MEYLE-HD: Better than OE.
Improved bushing design

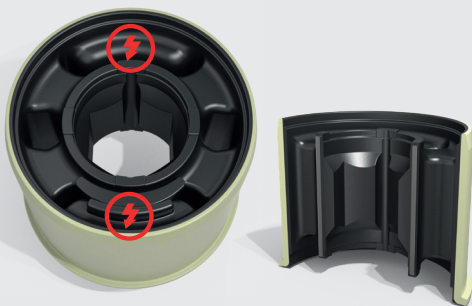
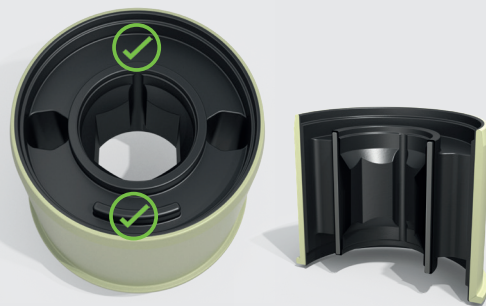
Problem

- Failure of the bushing due to intense strain

Effect

- Cracks in the rubber material
- Impaired driving safety

Solution

- Optimized design reduces stress in critical areas

Advantage

- Significantly longer lifetime due to less cracks in the rubber material
- Longer driving safety
- 4-year warranty
